MFN 09-023 Supplement 5

**Subject: Transmittal of Supplemental Information Regarding GEH Response to NRC Request for Additional Information (RAI) Number 6.2-140 S06**

**Transmittal of Supplemental Information Regarding GEH  
Response to NRC Request for Additional Information (RAI)  
Number 6.2-140 S06**

### **RAI 6.2-140 S06 - Fan Flow Chatter**

**Figure 1 Main Steam Line Break (Bounding Case) PCC Vent Fan Volumetric Flow**

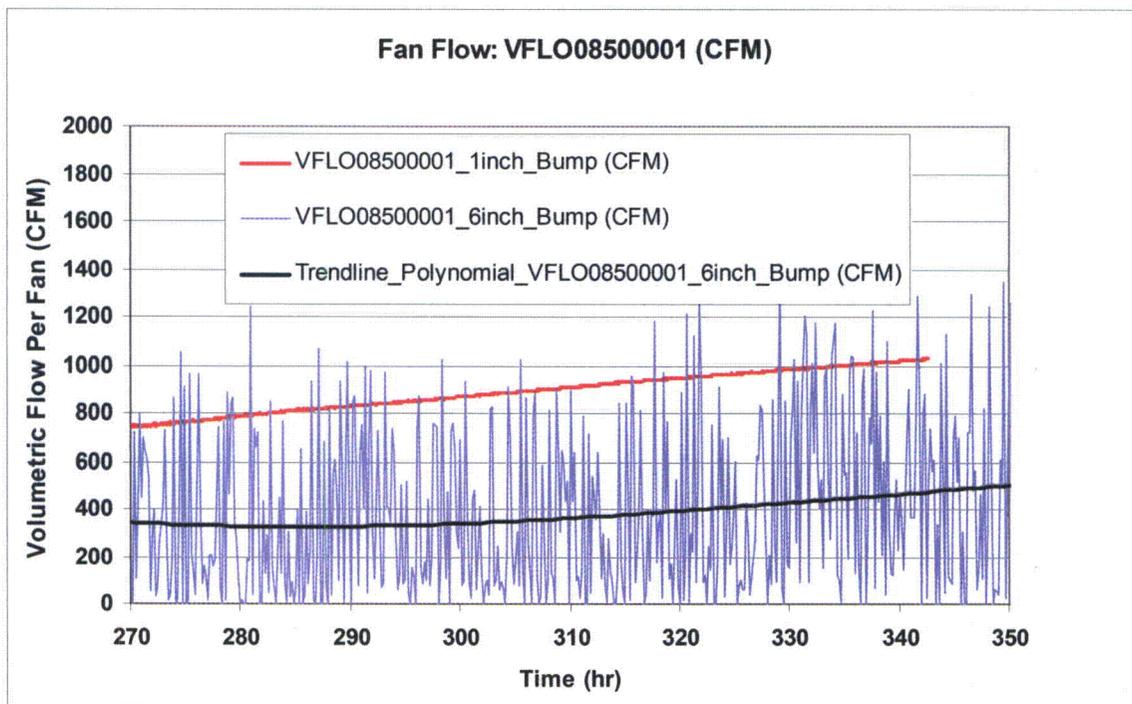
The chatter (oscillation) in vent fan performance in the TRACG analysis with 16-inch fan discharge submergence (6 inch bump in submergence) at about 269.4 hours in RAI 6.2-140 S06 response does not occur when the submergence is changed to 11 inches (1 inch bump), as indicated in Figures 1 and 2. Each of the figures include a polynomial fit trend line for the 16 inch submergence case that has chatter, to indicate the general trend with time for the fan flow and fan head.

Because the tray will limit the discharge submergence to 10", the chatter in the fan parameters is not expected in the DBA LOCA.

Figure 3 Main Steam Line Break (Bounding Case) Containment Pressure

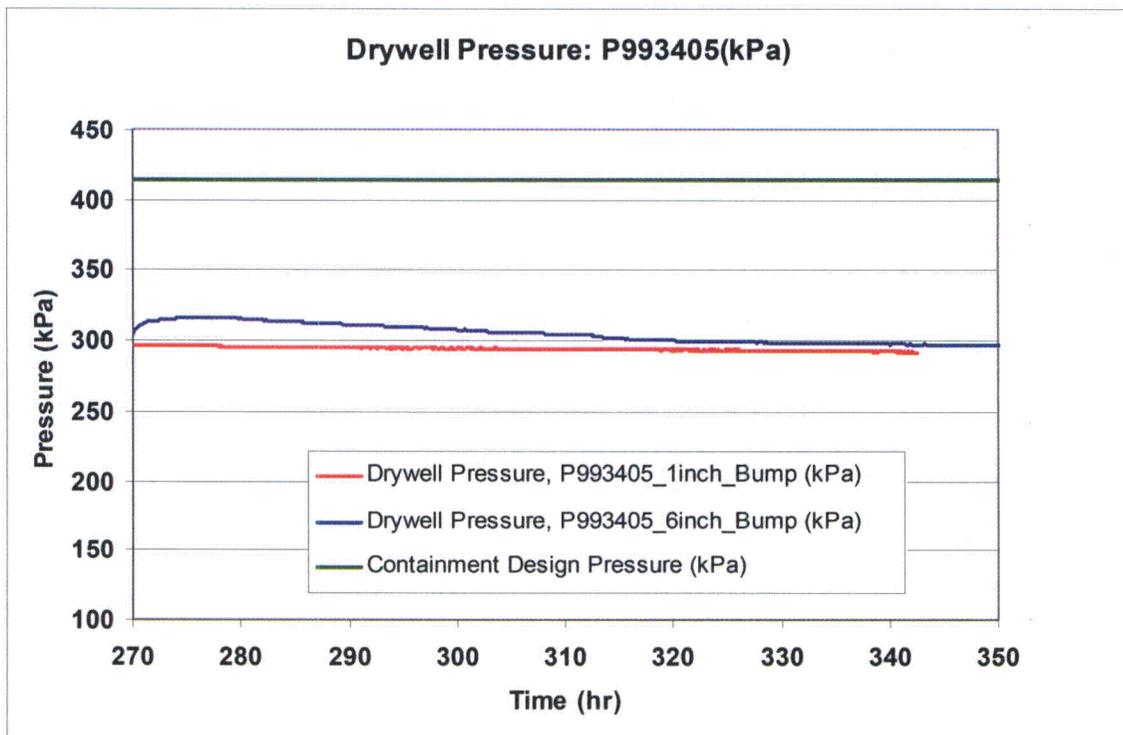
The containment pressure response provided in RAI 6.2-140 S06 remains bounding as shown in Figure 3. This is because with a larger submergence, the fan flow rate is lower, the PCC flow rate is lower, and the containment pressure is higher than that with a smaller, more realistic submergence.

The containment pressure (figure of merit) resulting from this restart case with 6-inch bump (16 inch submergence) case was substantially below the containment design pressure (Figure 3). The fan discharge submergence remained greater than ten inches.
